SUBJECT: RESPONSE TO MONTHLY PROGRESS REPORT FOR DECEMBER 1985 (FIN B6985)

Subject: Contract No. NRC-02-81-026
Benchmarking of Computer Codes and Licensing Assistance
Monthly Letter Progress Report for December 1985

TECHNICAL STATUS REPORT ATTACHMENT
TO PROGRESS REPORT FOR DECEMBER 1985

TEMPERATURE ERRORS AT RADIATIVE FACE

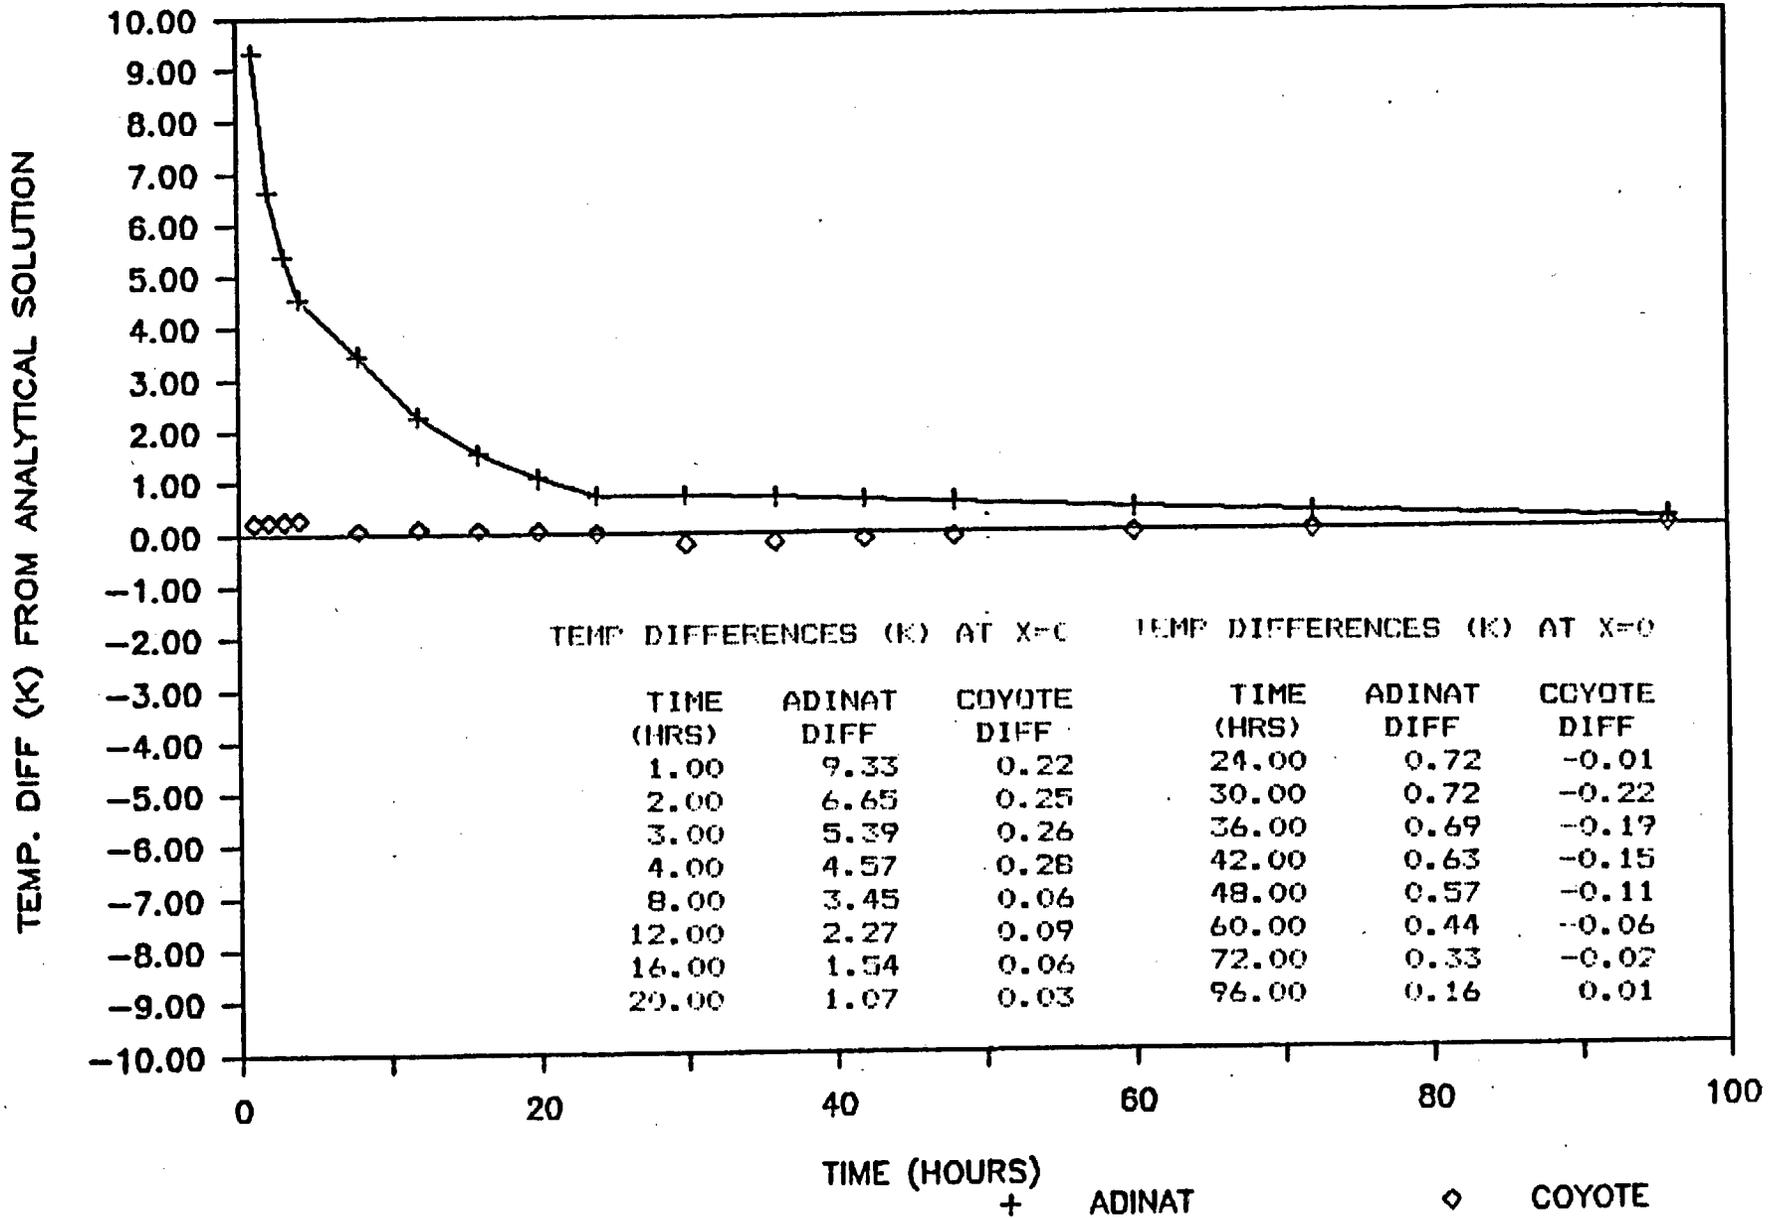
As you study the reasons for the varying temperature errors at the radiative face and the insulated face for problem 2.9 when using the ADINAT and COYOTE codes, please advise us as to any changes in setting up problem 2.9 and their impact.
